SUBJECT: SUPPLEMENT IN RESPONSE TO DATA ADEQUACY
COMMENTS ON THE APPLICATION FOR CERTIFICATION FOR
THE SUN VALLEY ENERGY PROJECT (05-AFC-03)

In accordance with the provisions of Title 20, California Code of Regulations, Valle del Sol Energy, LLC hereby submits this document titled *Supplement in Response to Data Adequacy Comments on the Application for Certification for the Sun Valley Energy Project (05-AFC-03)*. The Sun Valley Energy Project is a 500 megawatt, natural gas-fired power plant to be located near Romoland, Riverside County, California.

Sun Valley Energy Project

(05-AFC-03)

Table 3-1. Barre - Villa Park Outage

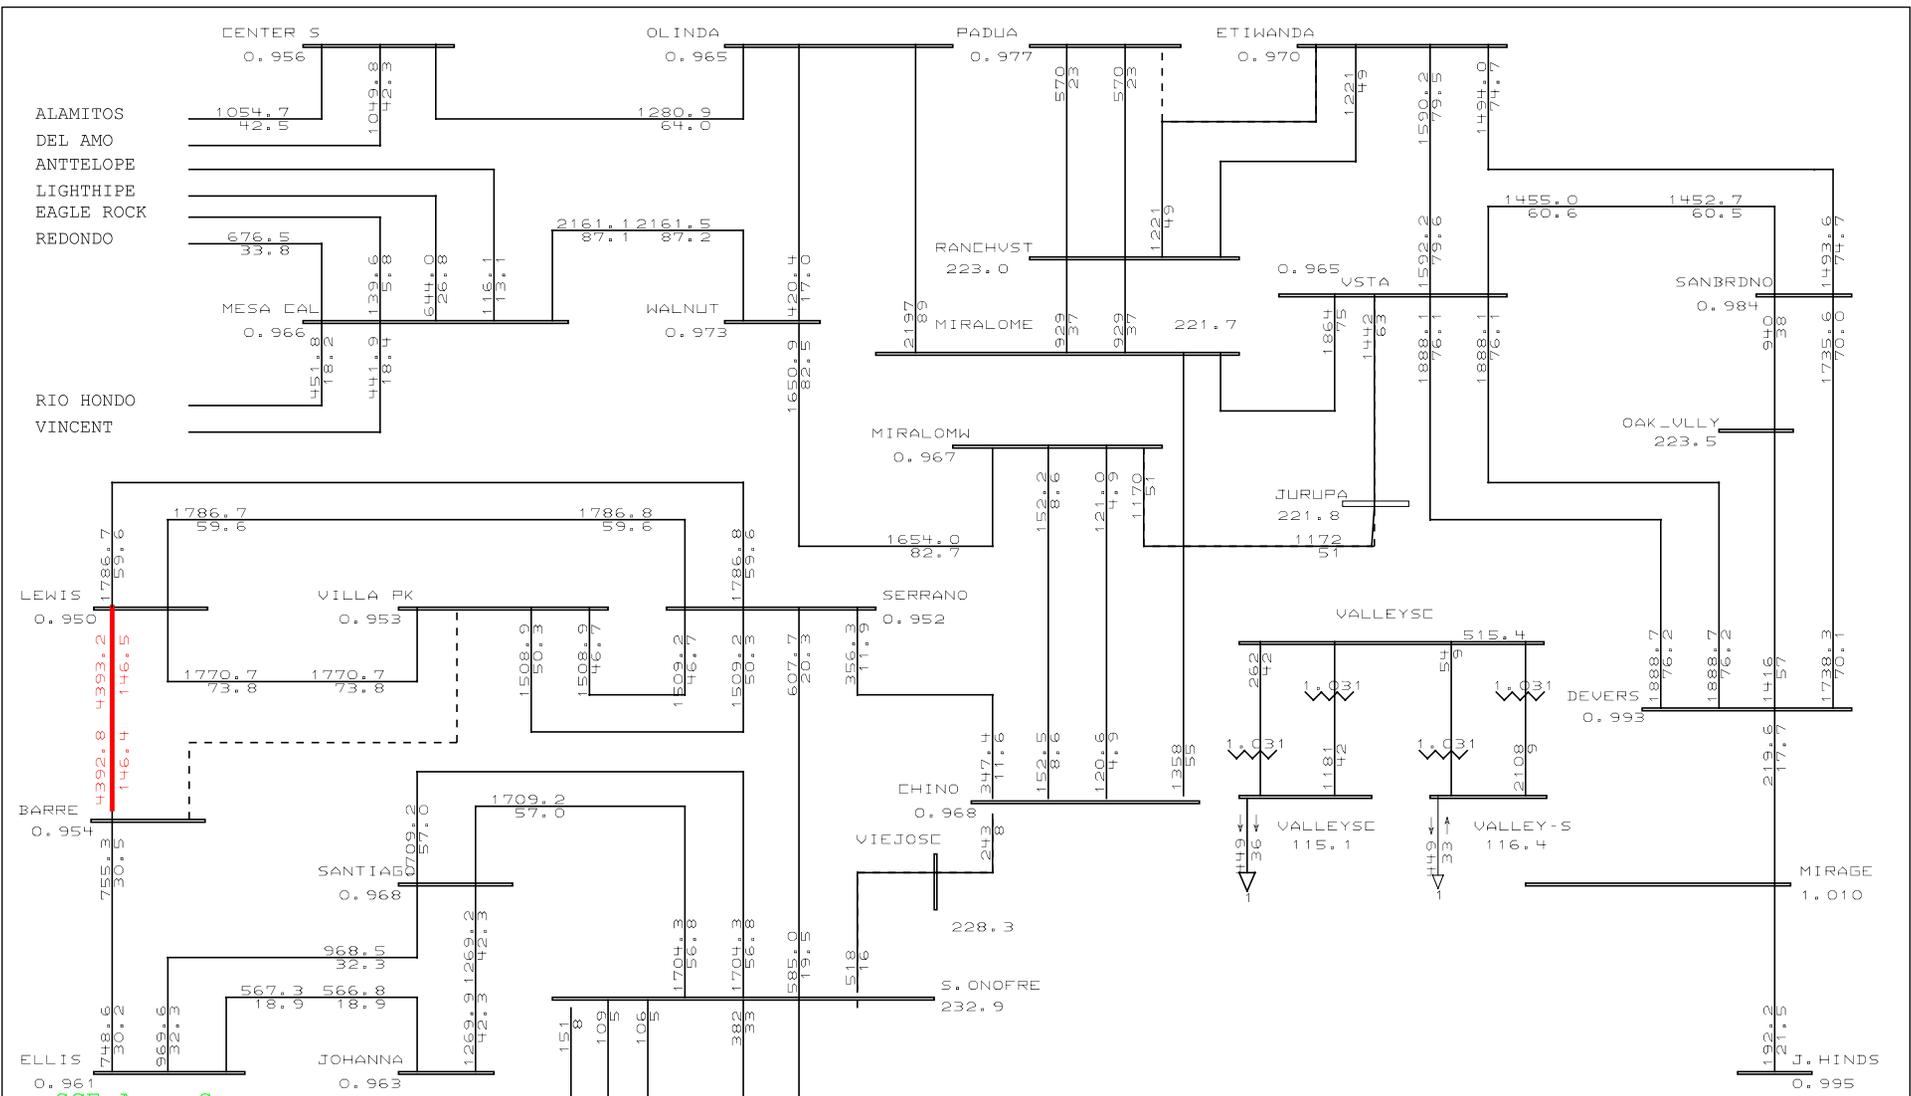
Provide power flow diagrams (MVA, % loading & P. U. voltage) for all N-1 and N-2 contingencies where overloads or voltage violations appear.

Response – Power flow diagrams for cases for which the SVEP would aggravate existing transmission system overloads are attached.
